St Johns Lodge

151 High Street, Lindfield.

Design and Access Statement – August 2025

Proposed Northern Elevation

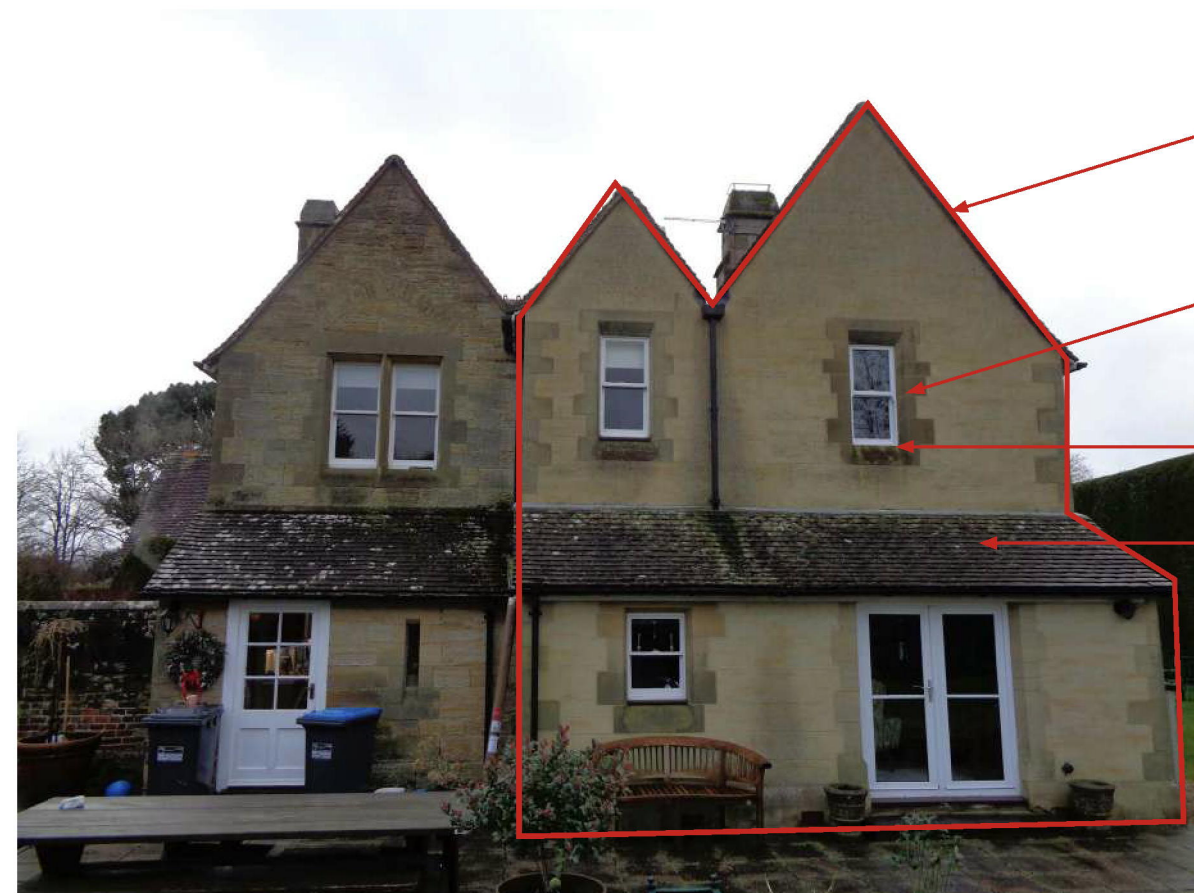
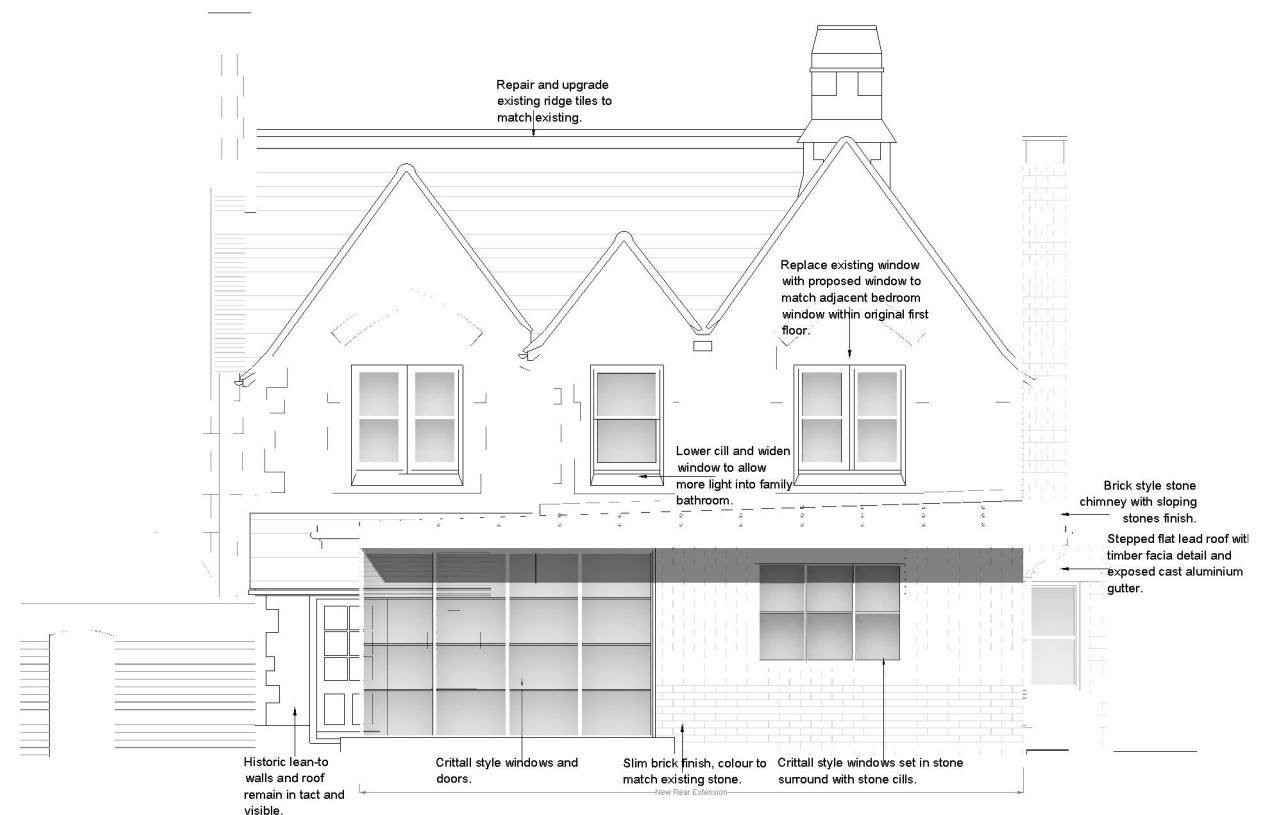
In my opinion, given the scale of the existing modern additions to the rear of the house any further substantial extension to the property is likely to be considered contentious in principle. The proposed single storey rear addition is on a very sizeable footprint, extending across the full width of the rear of the building. It is, in my opinion, over scaled and overbearing in its relationship with the relatively modest footprint of the original house, resulting (particularly when viewed cumulatively with the existing two storey extensions) in an inappropriate relationship of scale between the historic core of the building and the additions to it. Furthermore the last remaining element of the original elevation at this level would be lost or internalised.

I would suggest that the maximum which may be achievable at the rear of the building would be a significantly less deep single storey addition sitting solely across the existing rear infill extension, replacing and slightly extending the footprint of the existing lean-to element in this position. The adjacent original lean-to should be retained unaltered. Subject to an appropriately reduced scale, I would have no particular objection, subject to detail, to a flat roofed form, although in terms of the elevations a lighter-weight treatment, not featuring for example entirely solid end elevations, would be preferable in reducing the apparent bulk of the addition.

Through our design development, our initial proposals for a full width, single storey stone extension with decorative quoin details and timber sash windows created too much bulk and covered the historic lean-to which was not favourable with the planning team.

Following this feedback and discussions with the Heritage consultant we have substantially reduced the width and scale of the proposed rear extension to minimise impact on the original house.

We note your suggestion for a more modest single-storey addition confined to the footprint of the existing rear infill extension, with the adjacent original lean-to retained unaltered.

While we appreciate the intent to limit depth, we consider that a slightly extended footprint is necessary to achieve functional internal layouts which are proportionate to the extended house as it stands, and entirely balanced with the needs of a 5 bedroom dwelling.

The revised scheme now retains the historic lean-to in its entirety, ensuring it remains fully visible from the rear garden, and adopts a restrained overall depth compared with earlier iterations.

In response to these concerns, we have proposed a lighter, more transparent single-storey extension, carefully limited to the footprint of the later 1980s addition.
